Access Audit Site Report

Stephen F. Austin State Park

Accessibility Evaluation

Inspection Date: 08/18/2022

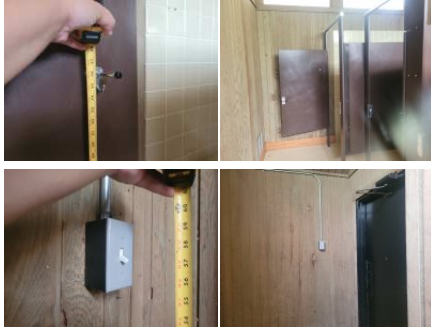
Finding Number	Area Description	Lat/Long	Finding	As Built	Recommendation	Citation	Photos	Figure
307	Group Dining Hall: Group Dining - Public Spaces	[29.8219191, -96.1131374]	There is a change in level greater than 1/4 inch. 1/4 inch is the maximum vertical rise. Changes in level between 1/4 inch and 1/2 inch must be beveled at 1:2 or less. Changes in level greater than 1/2 inch must be by way of a ramp.	CIL where floor buckling	Repair, bevel or ramp CIL along accessible route (AR) to max .25".	2015 ABAAS Section: 303.3 2012 TAS Section: 303.3 2010 ADAS Section: 303.3		
308	Group Dining Hall: Group Dining - Public Spaces	[29.8219423, -96.1131293]	Openings in floor or ground surfaces shall not allow passage of a sphere more than 1/2 inch (13 mm) diameter except as allowed in 407.4.3, 409.4.3, 410.4, 810.5.3 and 810.10. Elongated openings shall be placed so that the long dimension is perpendicular to the dominant direction of travel.	2.5" gap	Fill and maintain gaps to max .5".	2015 ABAAS Section: 302.3 2012 TAS Section: 302.3 2010 ADAS Section: 302.3

309	Group Dining Hall: Group Dining - Public Spaces	[29.82194, -96.1131374]	Picnic tables shall provide at least one wheelchair space for each 24 linear feet (7320 mm) of usable table surface perimeter. Wheelchair spaces shall be 30 inches (760 mm) minimum by 48 inches (1220 mm) minimum. Wheelchair spaces shall be positioned for a forward approach to the table and provide knee and toe clearance complying with 306 under the table.	0 of 10 tables accessible	Replace picnic table with one of an accessible design as a smart practice.	2015 ABAAS Section: 1011.4.2
